**APPROACH TO RESOLVING  
RAI LETTERS 77 AND 79**

**Fermi 3 COLA**

**November 29, 2012**

Figure 2a FRS - X-Direction from SER-DTF-006 (Licensing Basis Analysis)

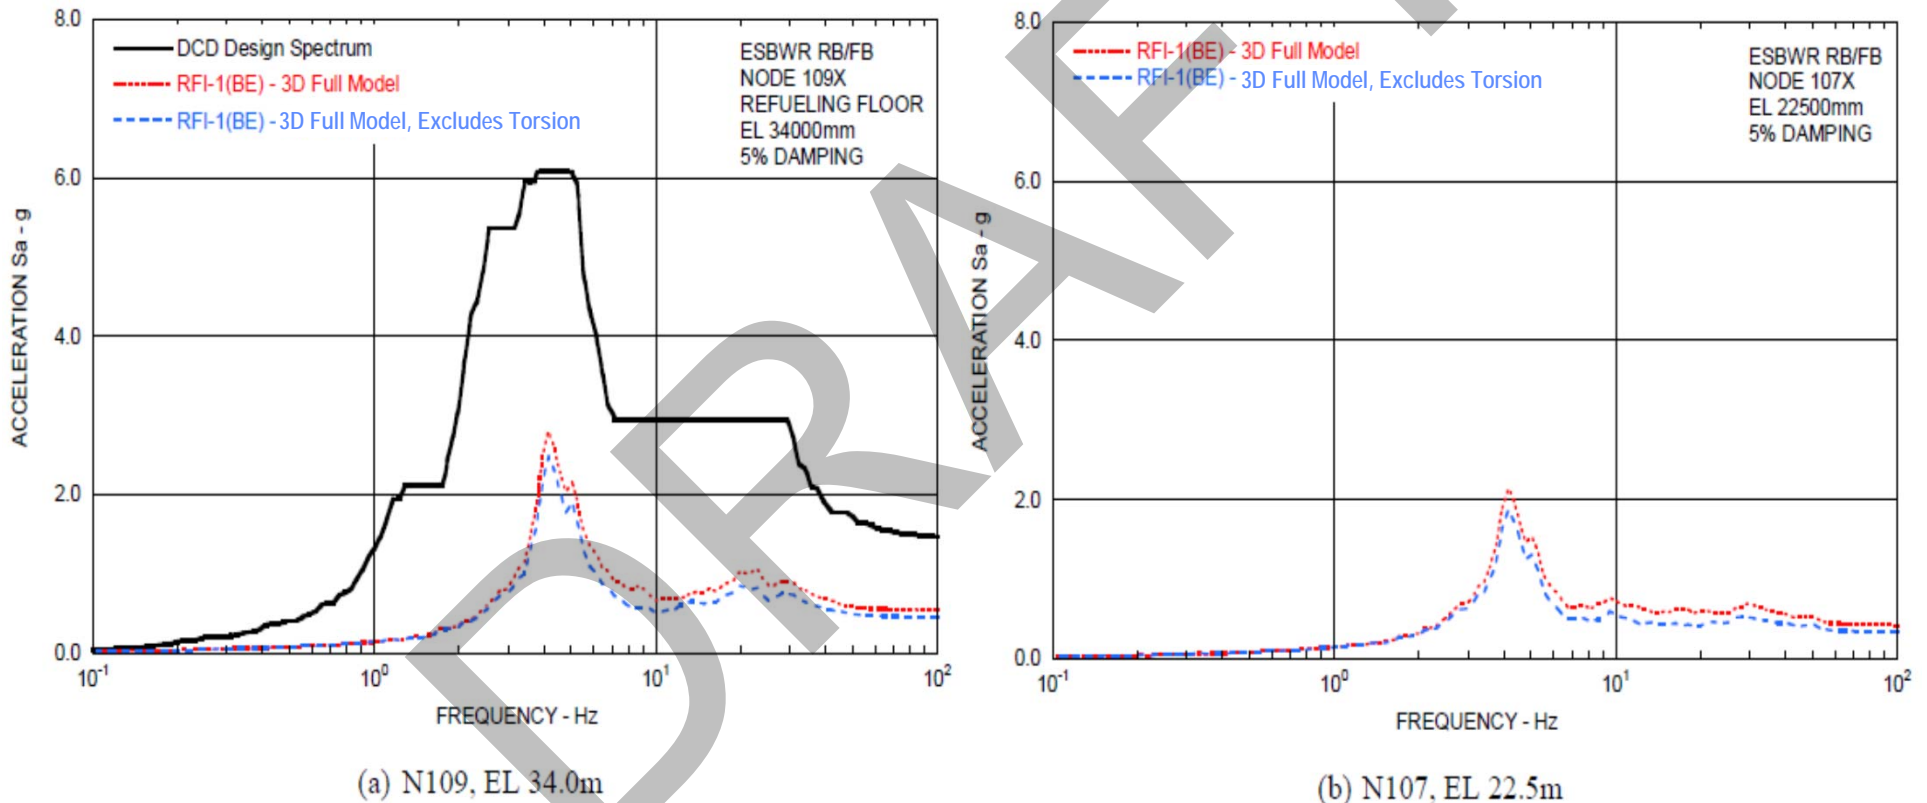
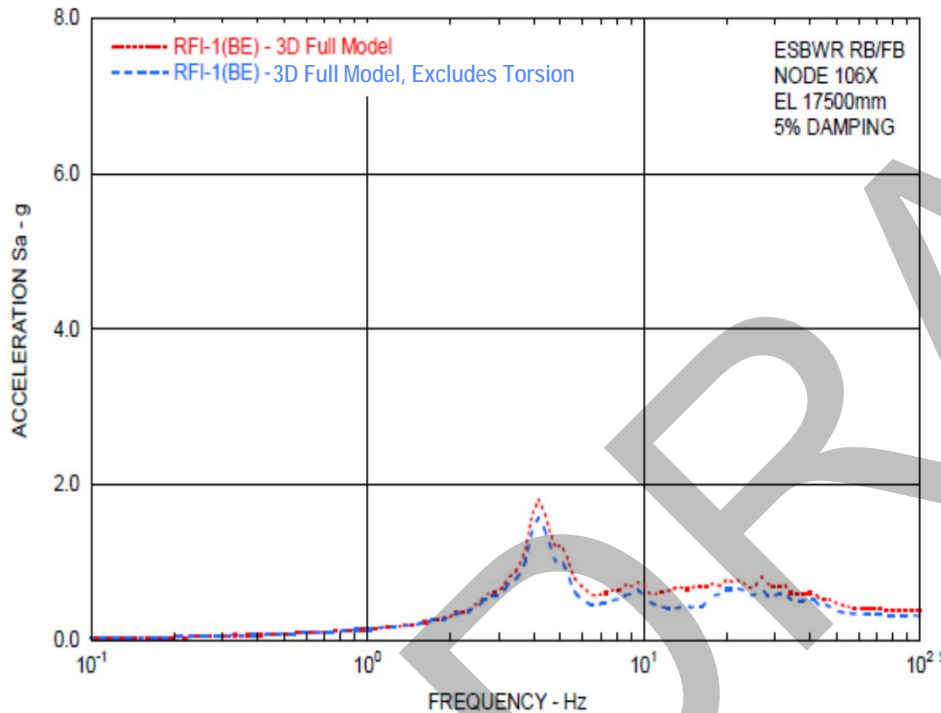
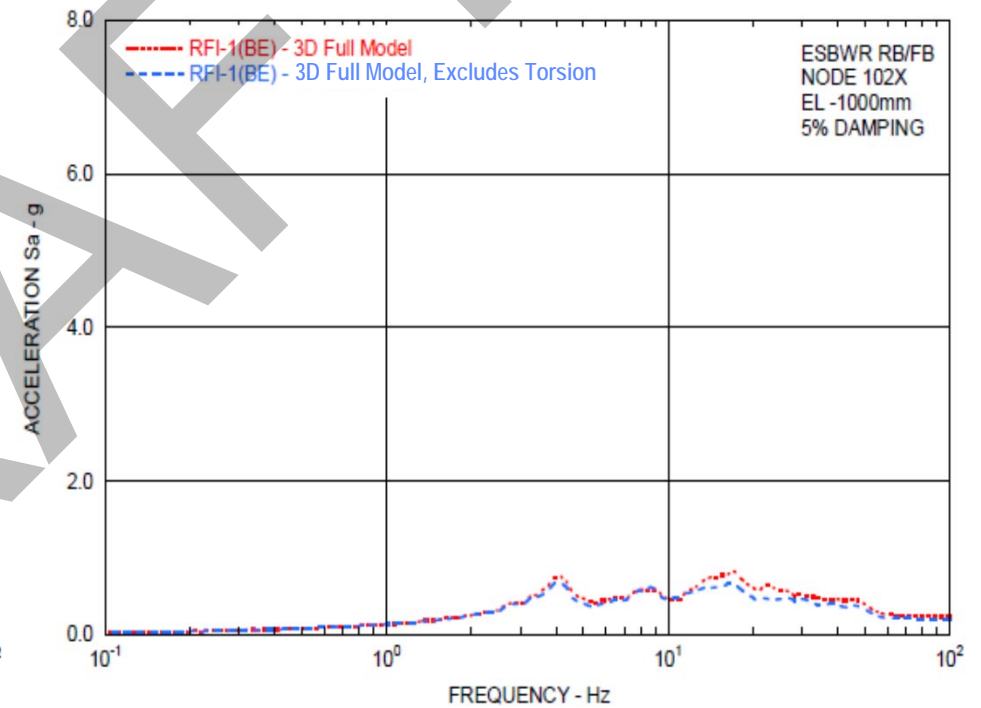
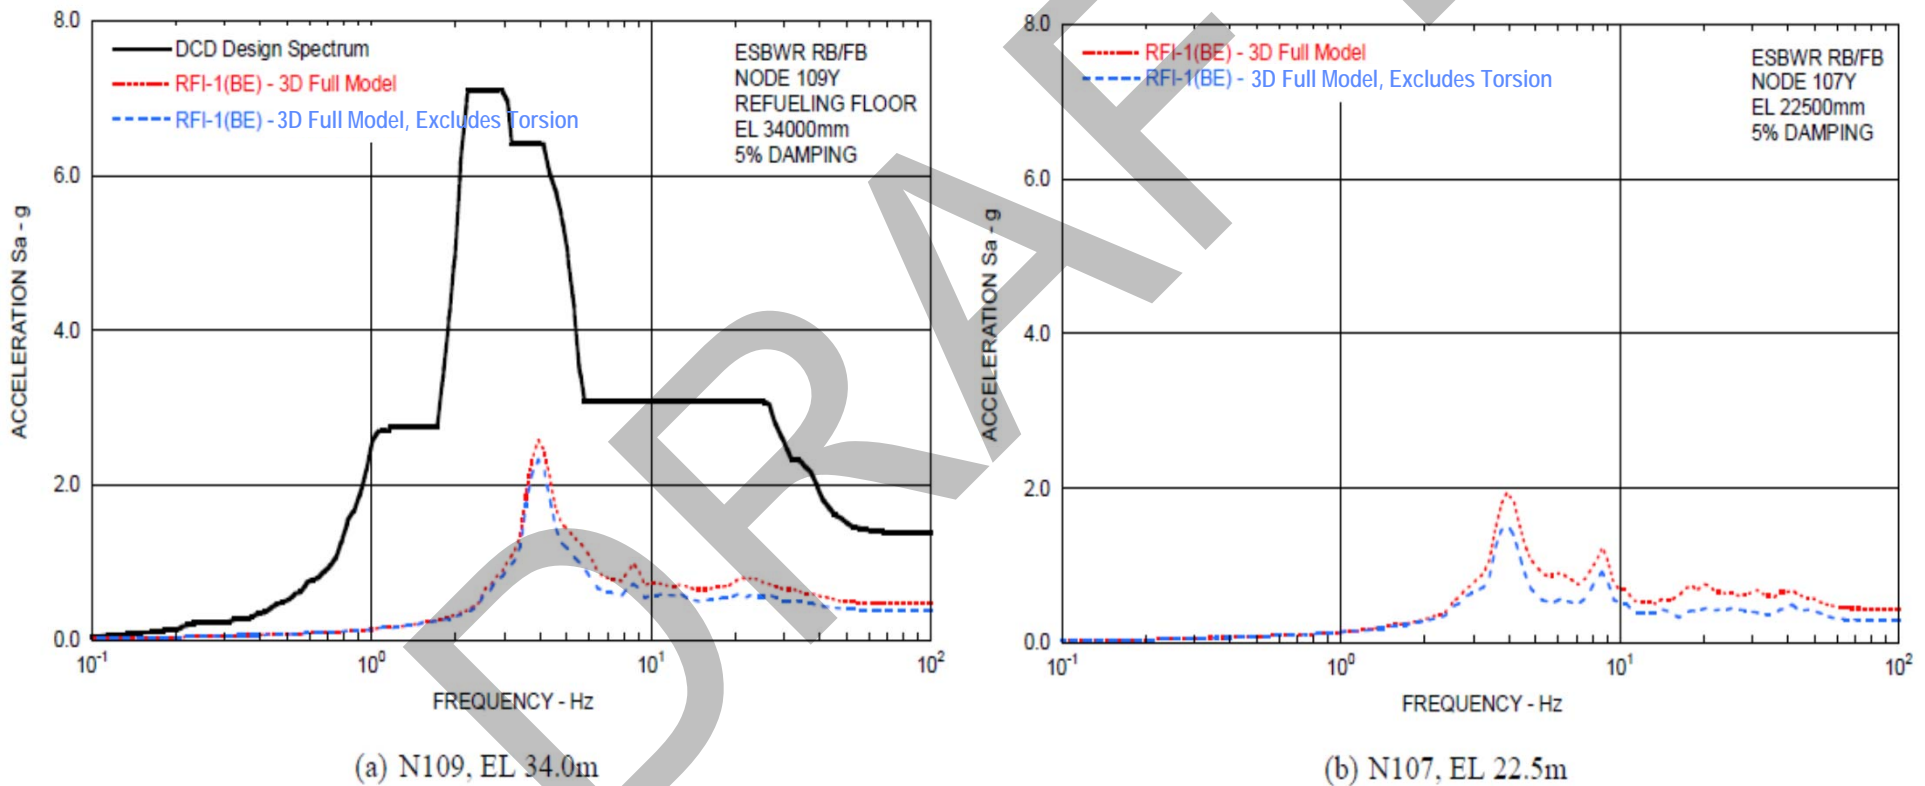
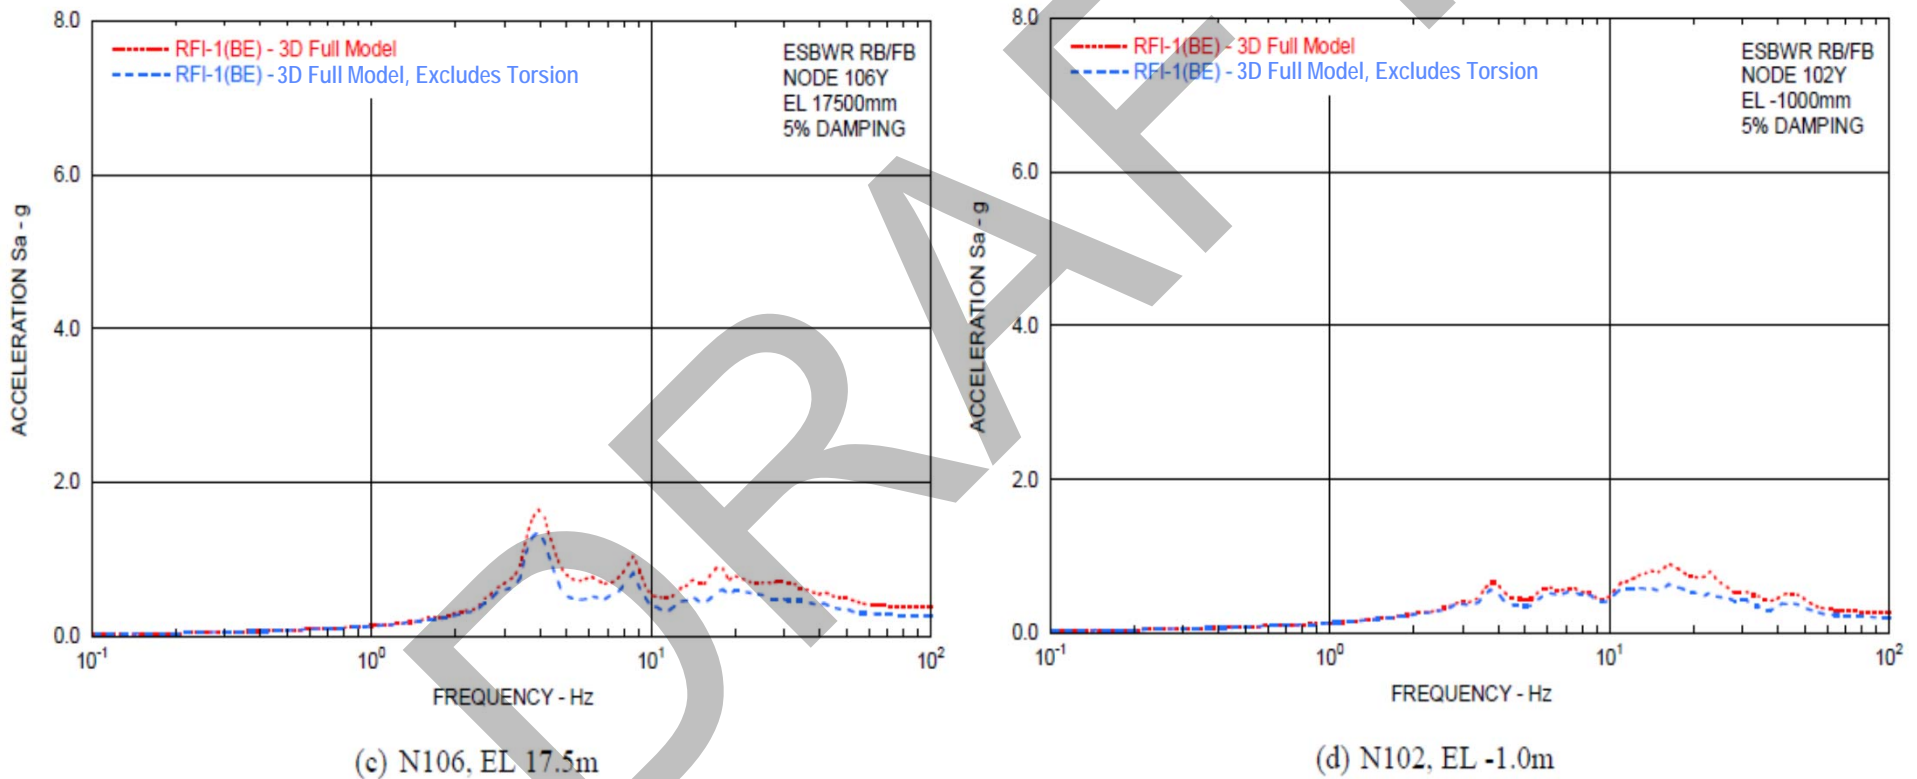
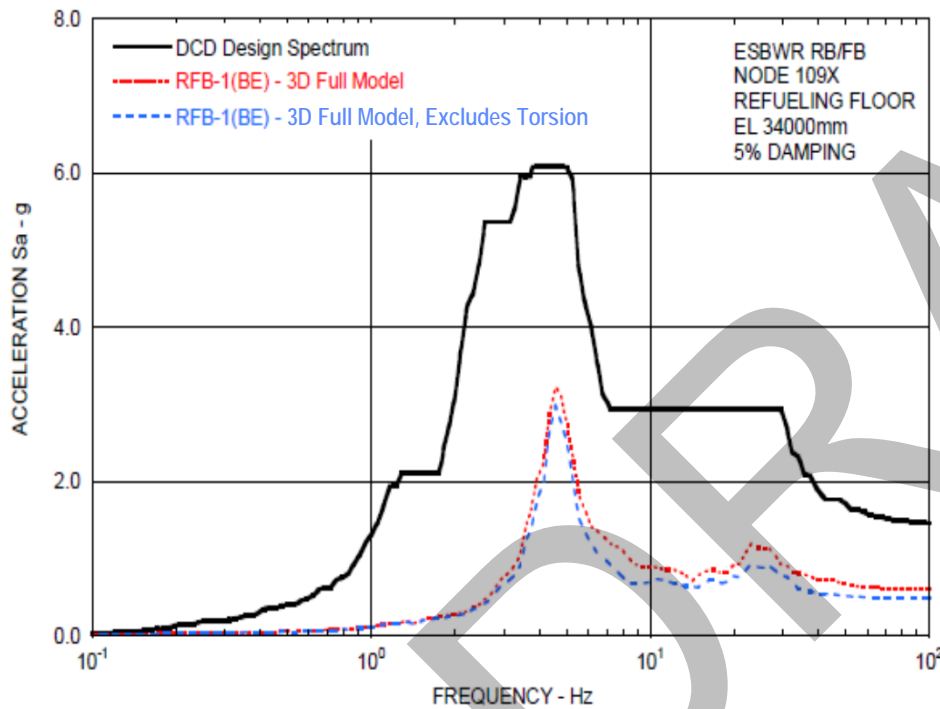
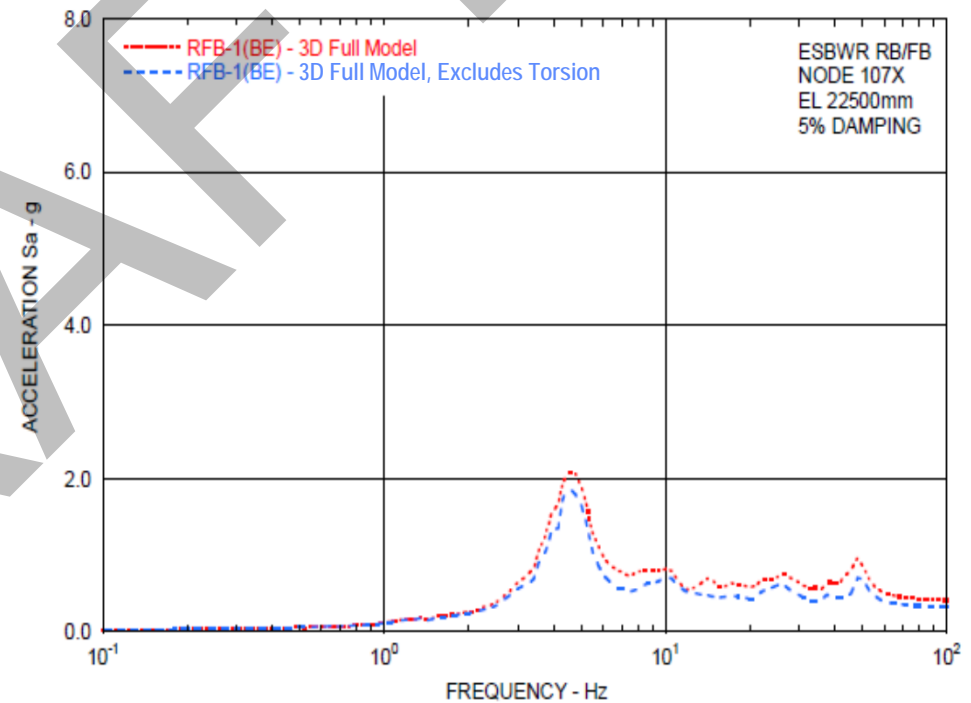
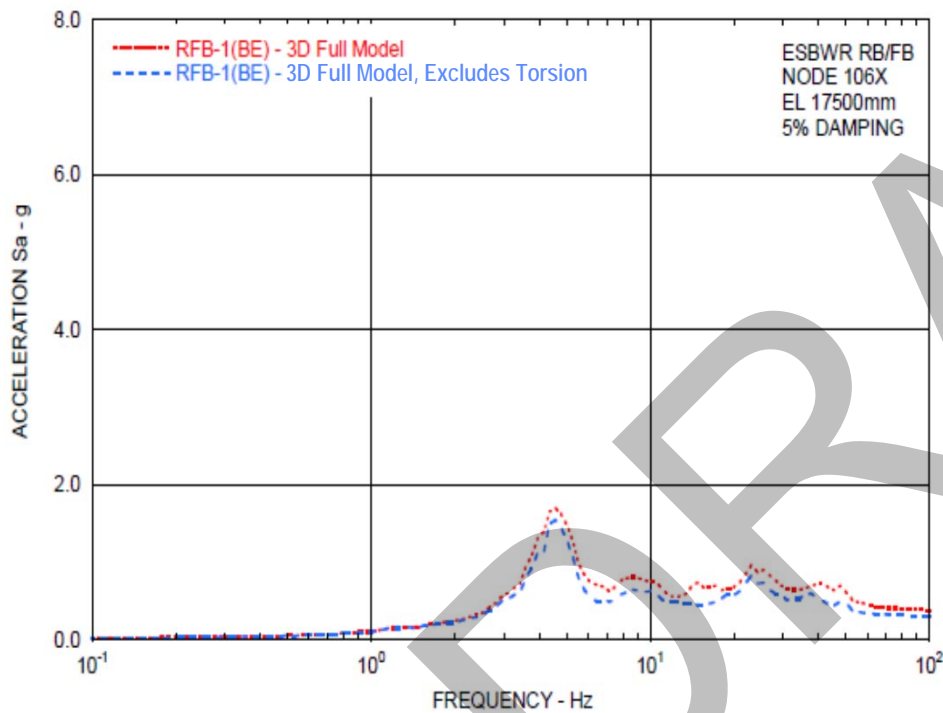
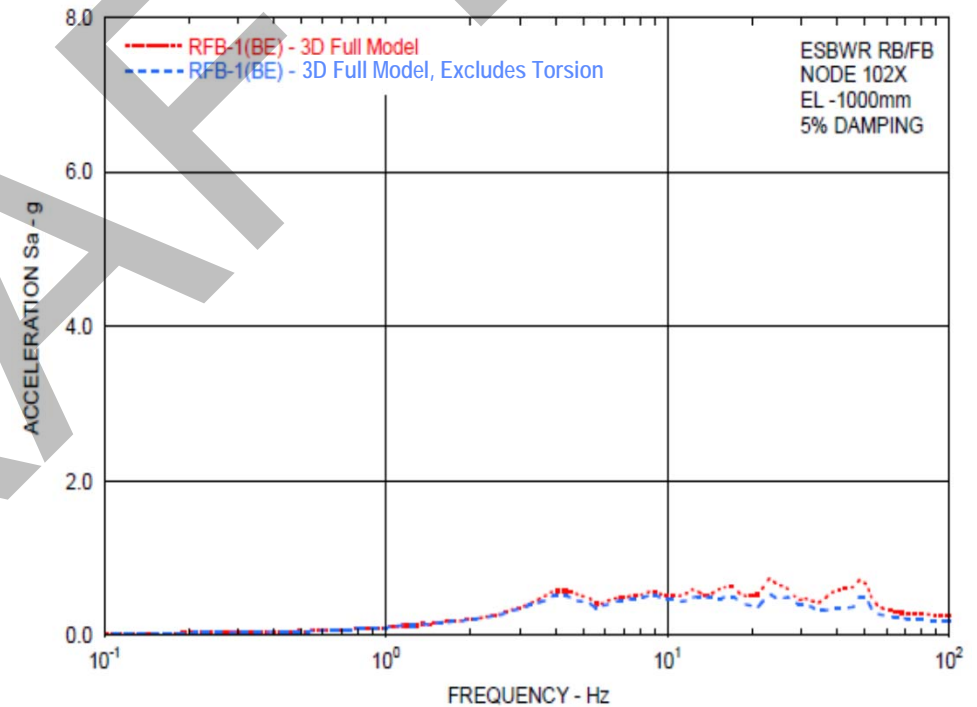
- The calculated floor elevations are selected at nodes N109, N107, N106 and N102 (Figure 1)
- Figures 2 through 5 show the comparison of the FRS between the 3D Full Model with and without the torsion components

- Figures 2 and 3 show the results from the Licensing Basis Analysis for the X and Y directions, respectively
  - Figures 4 and 5 show the results from the Confirmatory Analysis with Backfill for the X and Y directions, respectively

- The differences in FRS in X direction are small
- The difference of FRS in Y direction are larger but not significant
